SUNDRY NOTICES AND REPORTS ON WELLS

H.M. BRITT #11

30-025-05998

RE: Plugging and Abandonment Requirements, Conditions of Approval

PLUGGING & ABANDONMENT WORKSHEET

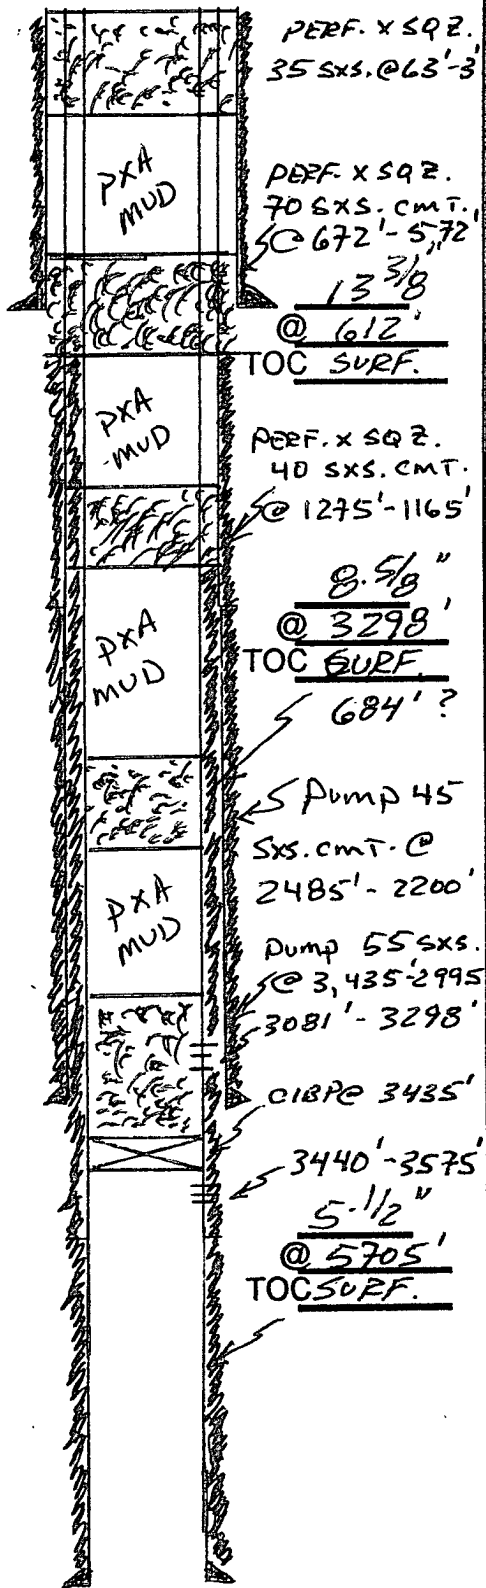
1. Change: Perf at top of CIBP squeeze cement in and out from +/-3435'-3245'. WOC and tag at 3245' or shallower. If injection rate cannot be established, spot cement on top of CIBP (Perfs – Casing shoe)
2. Tag at 2200' or shallower – Otherwise OK (Yates – BOS)
3. Tag at 1165' or shallower – Otherwise OK (TOS)
4. Be sure to attempt to fill the 8-5/8"x13-3/8" annulus. Tag at 572' or shallower – Otherwise OK (Casing Shoe)
5. OK (Surface)
6. Verify Cement to surface in all annuluses – Otherwise OK.
7. Submit a subsequent report to the BLM.
